ADDENDUM NO. 2

City of Chattanooga
Eastgate Family Justice Center
Derthick Henley & Wilkerson Architects

Date: 21 Sep 2015

Reflected Ceiling Plan Legend

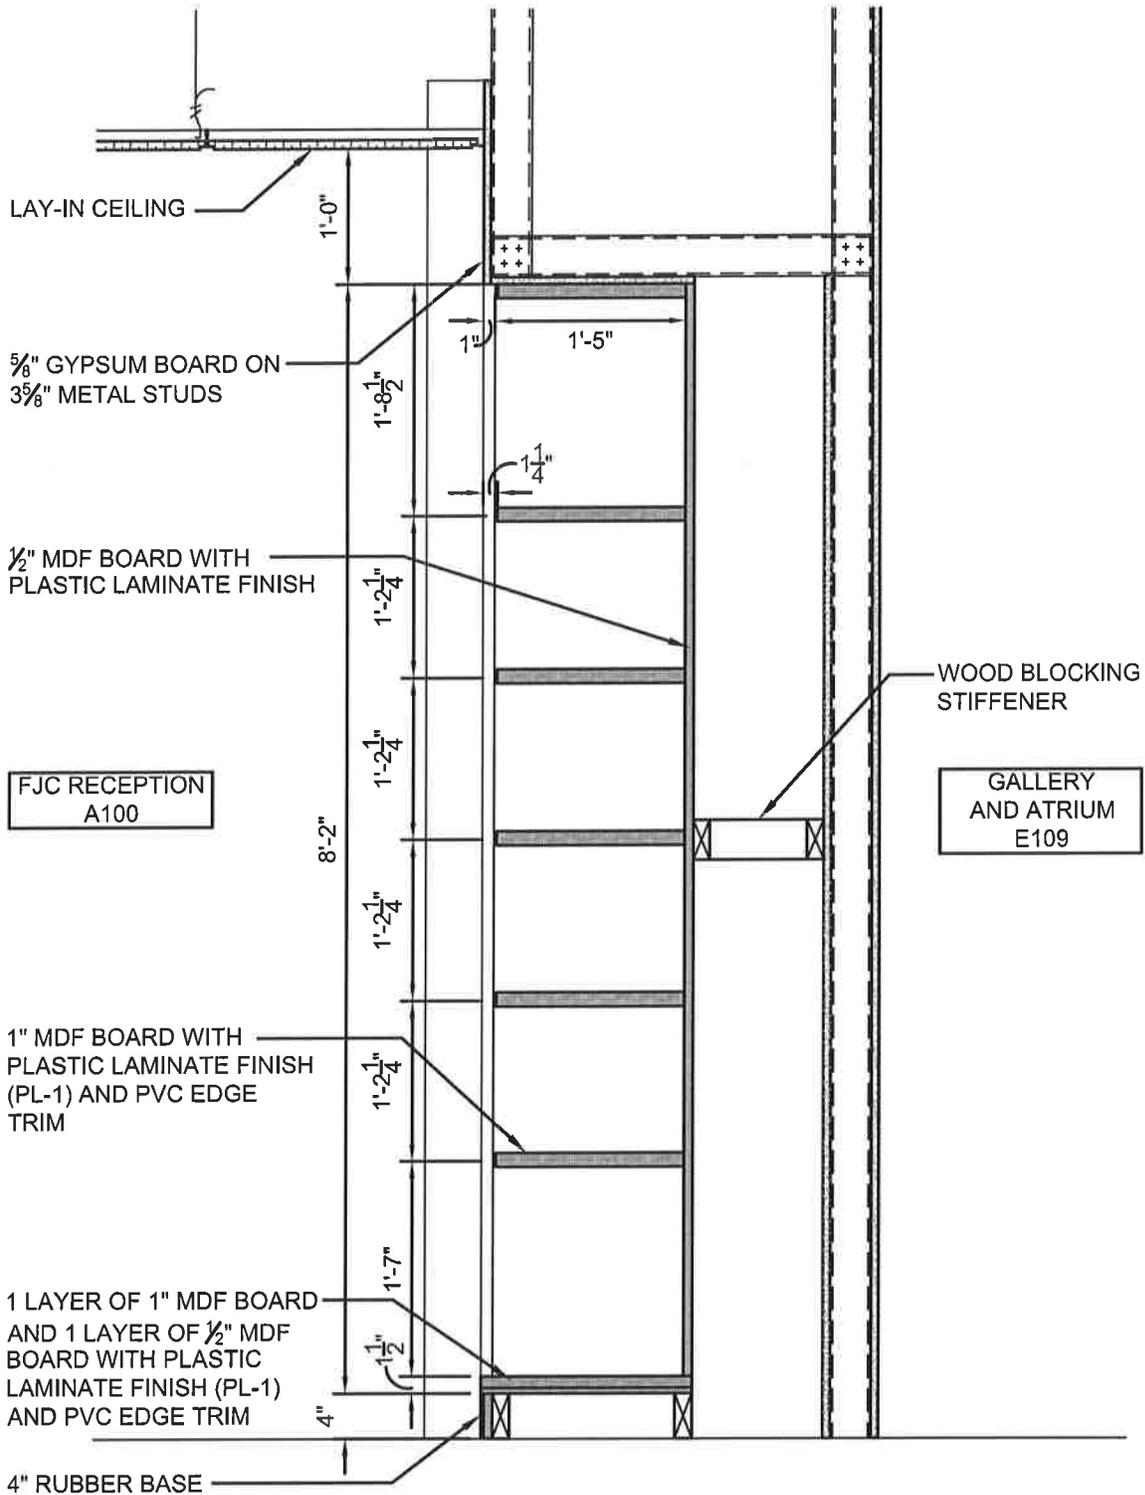
Skylight is removed from the scope of work. Alcove in the Atrium and Gallery (Room E109) to be a gypsum board ceiling noted as CN-1.

ADDENDUM NO. 2
 PARTIAL LIGHTING PLAN - SOUTH

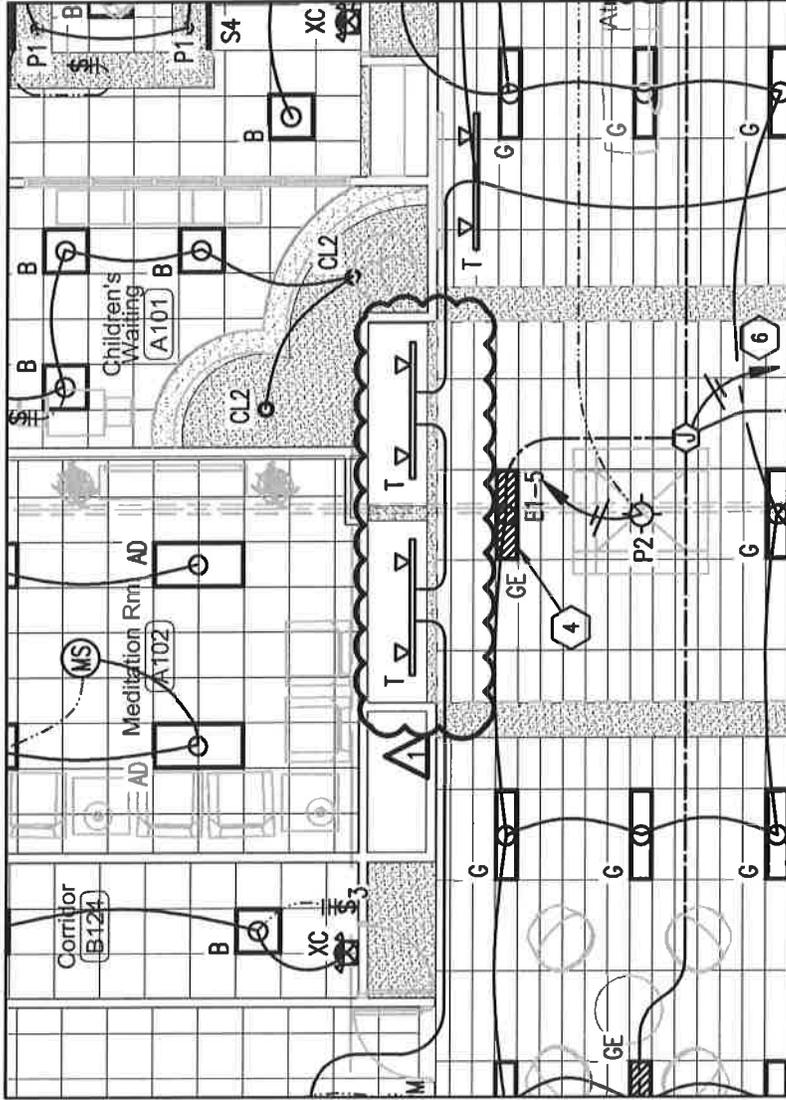
Add two Type 'T' lighting fixtures at Atrium. Connect to and control with track lighting circuit
See the attached drawing:

THE
 Canopy and
 Fence Details
 SCALE: AS SHOWN
 SHEET NO. A-310

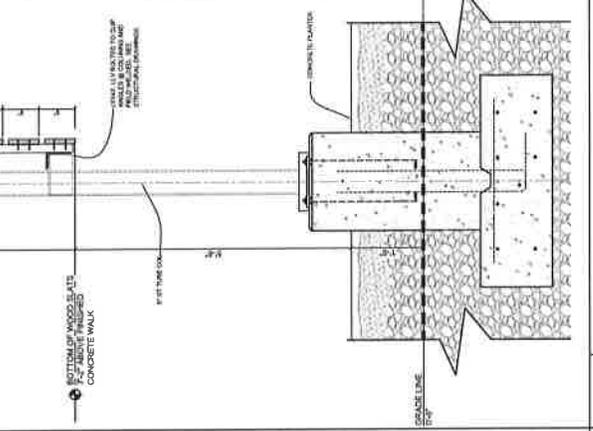
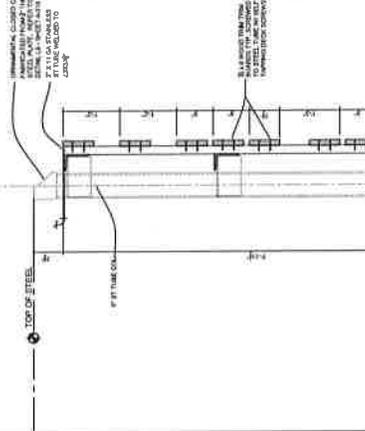
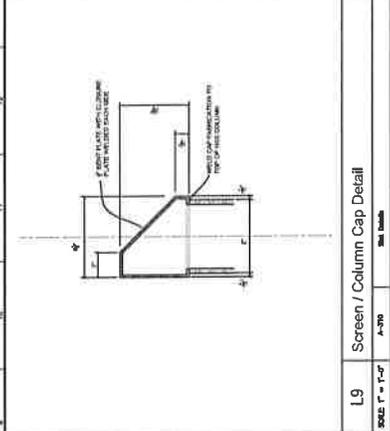
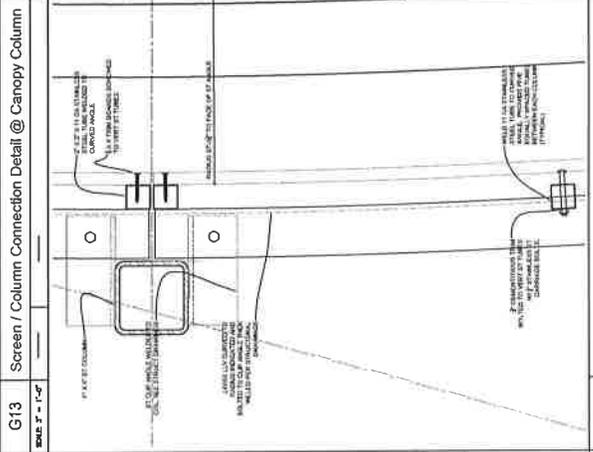
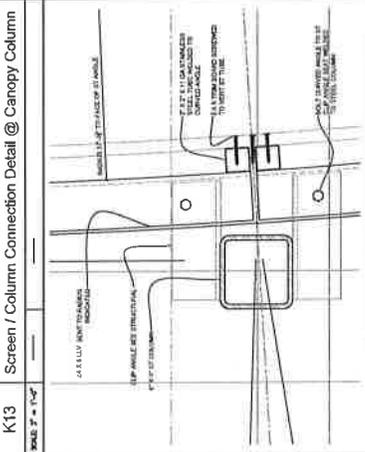
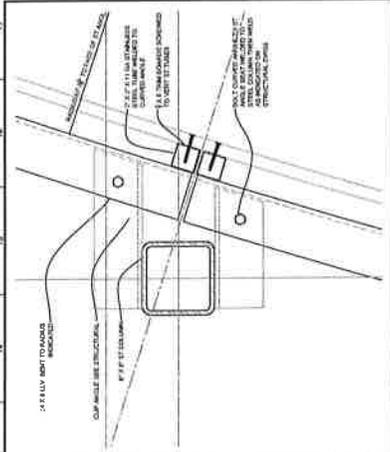
Locates Green Screen and renames the detail. Note that all Green Screen elements are part of Alternate No. 1.
